Attachment B

OEH Science Division

Review of Springvale and Angus Place Mine Extension EISs

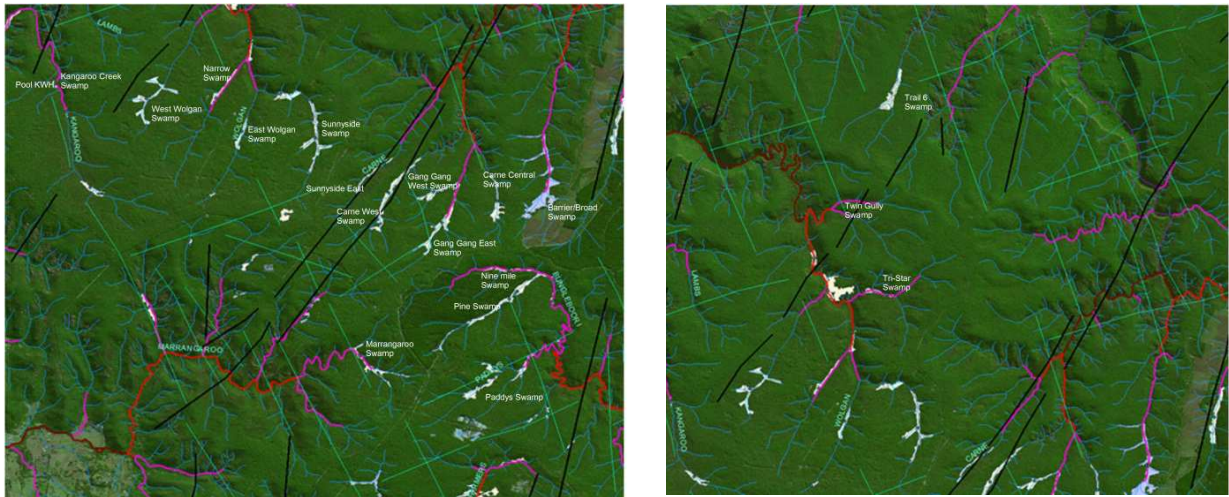
For Springvale, MSEC 2014a only discusses Wolgan River and Carne Creek specifically, with all other streams included under the generalized term “drainage lines”. This is despite 3rd order stream sections occurring within and downstream of Gang Gang East and Marangaroo Creek swamps which will be directly mined beneath (see Figure 1).

OEH considers that these streams have the potential to be fractured and drained. OEH notes no detail or specific predictions for these 3rd order streams (apart from point estimates for swamps) or any commitment to remediate these 3rd order streams if impacts occur. It is highly likely that fracturing of bedrock under the swamps and drainage of perched aquifers will also lead to a loss of flow in these 3rd order streams (see Figure 2 for the flow coming out of Gang Gang East Swamp on 26 May 2014, despite the seasonally unusual warm weather patterns prevalent at the time). There is no appropriate monitoring of flow in these streams which is capable of testing the veracity of the claims made in the EIS of no impact to flows.

For Angus Place mine, MSEC 2014b also only discusses Wolgan River and Carne Creek specifically with all other streams included under the generalized term “drainage lines”. This is despite 3rd order stream sections occurring above, within and

downstream of Twin Gully and Tri-Star swamps which will be directly mined beneath (see Figure 1).

OEH considers that these streams have the potential to be fractured and drained. OEH notes no detail or specific predictions for these 3rd order streams (apart from point estimates for swamps) or any commitment to remediate these 3rd order streams if impacts occur. It is highly likely that fracturing of bedrock under the swamps and drainage of perched aquifers will lead to a loss of flow in these 3rd order streams. There is no appropriate monitoring of flow in these streams which is capable of testing the veracity of the claims made in the EIS of no impact to flows.

Figure 3. Longwall mining impacts on piezometer levels in Swamp 1b (undermined; black line) compared to reference swamps (Den14 – blue line; Gallhers Tributary [“Leech”] Swamp – red line) . Source: Krogh (2013).

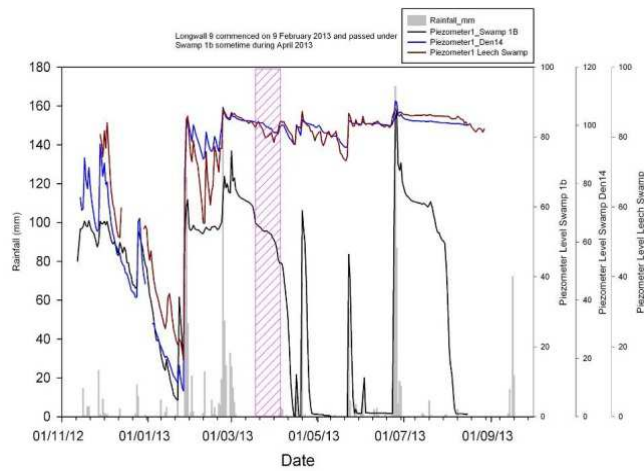
This is of concern as MSEC completed the last two end of block reports for Dendrobium (LW7 & LW8) and should be aware of documented and unequivocal impacts to coastal upland swamp EEC aquifers above the Dendrobium mine (eg Heritage Computing 2012, 2013; see also Krogh 2012). OEH has also recently been monitoring swamps above Dendrobium mine and these data demonstrate unequivocal swamp impacts due to the Dendrobium mine on Swamp 1B [drainage of perched aquifer in the swamp, increased desiccation (loss of soil moisture) of peaty sediments and lack of flow to the creek at the bottom of the swamp (Krogh 2013, see Figures 3-5)]. Similar impacts have also occurred at Swamp 15b, Swamp 1A, Swamp 5 and possibly Swamp 8 (e.g. Heritage Computing 2012, 2013; BHPBIC 2013).

Figure 6. Longwall mining impacts on groundwater levels within Kangaroo Ck Swamp (Red Line) compared to natural water level fluctuations in a reference swamp (Sunnyside Swamp; blue line), rainfall (vertical grey bars) and rainfall deficit (Black line). Source: DECCW 2010.

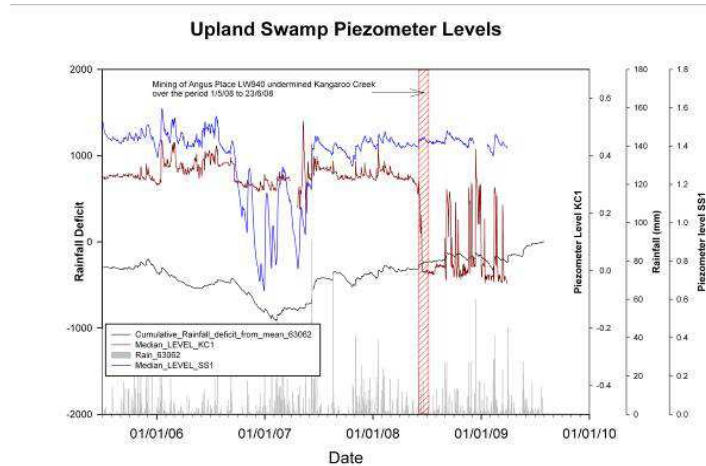
Section 5.12.3 of the Subsidence Impact Assessment detailing the history of mining beneath Angus Place and Springvale Collieries also omits any discussion of the mining impacts to Kangaroo Creek Swamp⁷ (Figure 6) or its upstream “permanent” waterhole KWH (Figures 7 & 8). The EIS reports also neglect to point out that LW940 was 262m wide and yet mining of this longwall still led to the loss of the permanent perched aquifer in Kangaroo Creek Swamp.

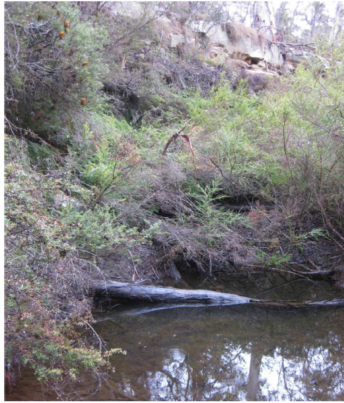
In addition, no mention is made of the fact that the spring which used to exist upstream of Kangaroo Creek Swamp is no longer flowing or that the dam further upstream is almost dry (Figure 9). Since these latter features have been directly undermined but inadequately monitored there are no details on the timing of these changes or whether they are related to specific longwall effects.

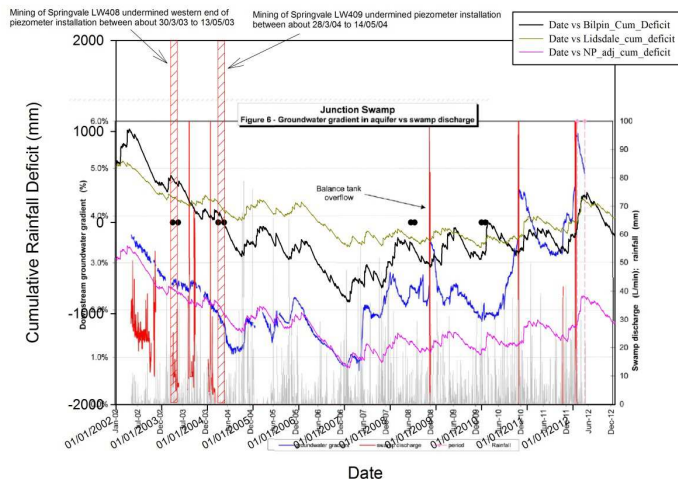
MSEC provide no scientific evidence that diverted surface water re-emerges in the catchment. Water drainage from East Wolgan Swamp was stated to have moved down to 70m (Aurecon 2009). There is also no mention in the EIS of the flow monitoring at Junction Swamp or explanation for why, post-mining of LW409, there has been virtually no flow in the creek line below Junction Swamp, except after heavy rain or a “balance tank overflow” (Figure 13). It is probable that flows in the creek line were once reasonable to warrant the size of the V-notch weir installed below Junction Swamp (Figure 13).

While there is little to suggest that LW408 impacted flows from Junction Swamp, no flow was recorded at the v-notch weir downstream of the swamp after the passage of LW409 and for approximately 6 years afterwards (discounting the balance tank overflow). Apart from the “balance tank overflow” [minewater?] around December 2008, some (assumed) rainfall related spikes in flow appear to have occurred close to December 2010, November 2011, and around March-April 2012. The recession of flows at these latter periods are very different (very abrupt) compared to pre-mining data. This is similar to what has actually been measured downstream of Swamp 1b after it was directly undermined and impacted by Dendrobium LW9 in the Southern Coalfields (Krogh 2013).

Figure 14. Water levels monitored in Carne Creek (CWP Waterhole). Source: RPS 2013.

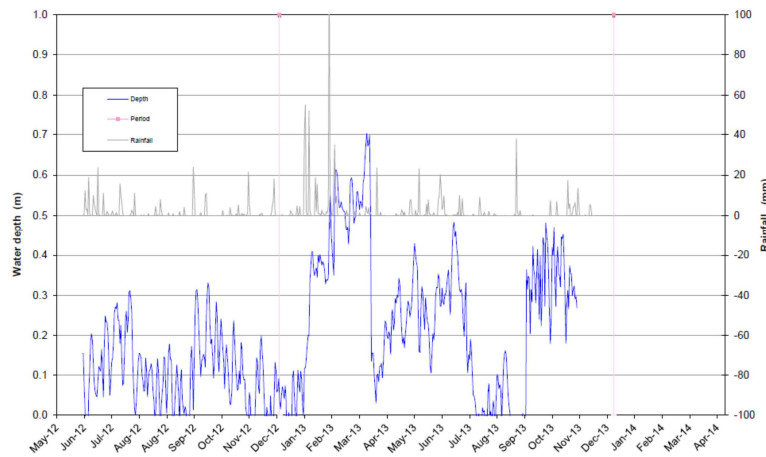
OEH believes that further consideration of pool recession rates might lead to a different conductance assumption for Pool KWH which could then potentially be used to model impacts in other areas of the model domain (ie in the swamps and streams directly above the proposed longwalls). Unfortunately Adhikary and Wilkins (2013) appear to accept that the spring above Pool KWH has not been affected based on "anecdotal evidence". As mentioned earlier, at OEH's last visit (May 2014) the spring was no longer flowing and Pool KWH was empty (as was the dam upstream). OEH has additional concerns about Adhikary and Wilkins (2013) assuming Carne West Swamp has ephemeral flows to CA4. OEH has consistently found water flowing from the downstream end of Carne West Swamp. Such a flow is supported by the relatively constant saturation of swamp sediments (high water level measured in lower Carne West Swamp piezometers). It is also supported by flow monitoring (by Aurecon 2011 [fortnightly pigmy flow meter records] and RPS 2013 [pool depth monitor, frequency not stated, but potentially daily or less; see Figure 14]).

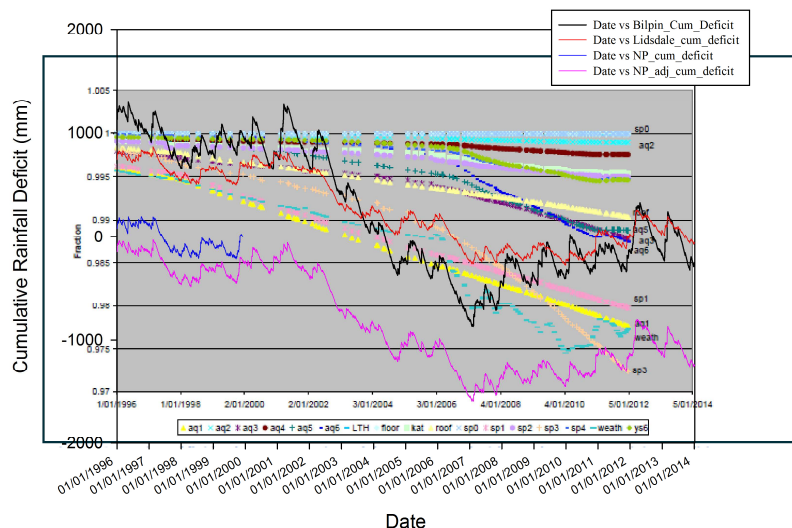
While there appears to be some relationship with rainfall deficit, the response suggested for the modelled response of the weathered zone appears to be much more complicated than a simple correlation with rainfall deficit – see Figure 15. For example, the model output appears to become increasingly sensitive to rainfall deficit as time (and presumably extent of mining) increases. Declines in water levels within the weathered zone could actually have important implications for NPSS and baseflow to streams. It would be interesting to see if this modelled effect is real or a function of model assumptions.
